Gecko International Co.						DATE	2026-5-7	DIMENSION	TOLERANCE
TITLE	MINI MOUNTING BUTTON					SCALE	FIT	$L \leq 4$	± 0.10
ARTICLE NO.	GMB	MOLD NO.	S0286/S1130/S1111	DRAW	LWJ	UNIT	MM	$4 < L \leq 15$	± 0.20
PART NO.	SEE TABLE	MATERIAL	SEE TABLE	DESIGN	LWJ	VERSION	A1	$15 < L \leq 50$	± 0.30
DWG NO.	E2168	COLOR	SEE TABLE	APPROVAL	FDL	VIEW		$50 < L \leq 100$	± 0.40

Fig.1

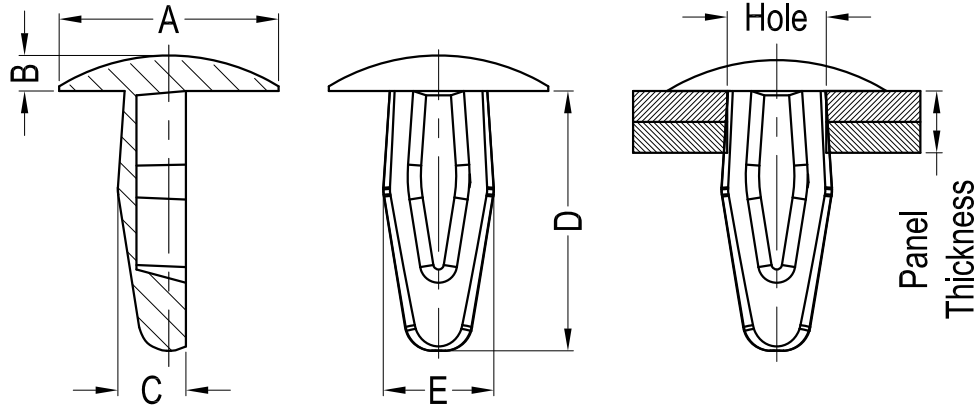
REV	DESCRIPTION	DATE	CHECK
A1	Revise the hole dia. from $\varnothing 3.32^{+0.26}_0$ mm to $\varnothing 3.42^{+0.16}_0$ for part GMB-136-06.	2026-5-7	FDL
